State of New Mexico Energy, Minerals and Natural Resources Department

30-045-25795 CENTRAL BISTI UNIT #085
DJR OPERATING, LLC
Application Type:

Re: Permanent Abandonment Well: Central Bisti Unit 85

PLUG AND ABANDONMENT PROCEDURE

Proposed P&A Bisti Gallup

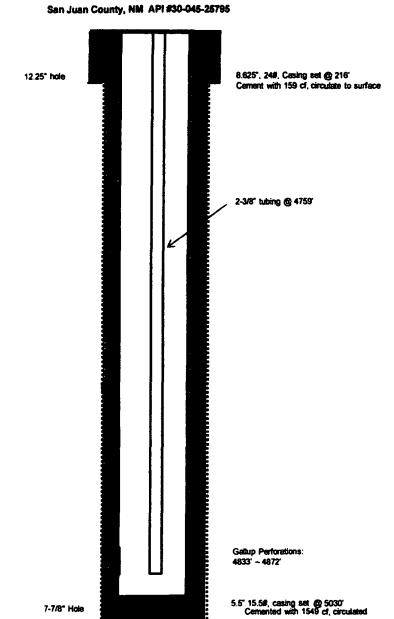
- Notify NMOCD 24hrs prior to beginning operations.
- Add additional plug 1,970'- 1,870'to cover the Mesaverde top. OCD Mesaverde pick @ 1,920'.
- Add additional plug 885'- 785'to cover the Fruitland top. OCD Fruitland pick @ 835'.
- Add additional plug 415'- 315'to cover the Kirtland top. OCD Kirtland pick @ 365'.

- 1. Plugging operations authorized are subject to the attached "General Requirements for Permanent Abandonment of Wells on Federal and Indian Lease."
- 2. Farmington Office is to be notified at least 24 hours before the plugging operations commence (505) 564-7750.
- 3. BLM picks top of Fruitland at 616 ft. Modify Plug #5 to cover 566-666 MD.
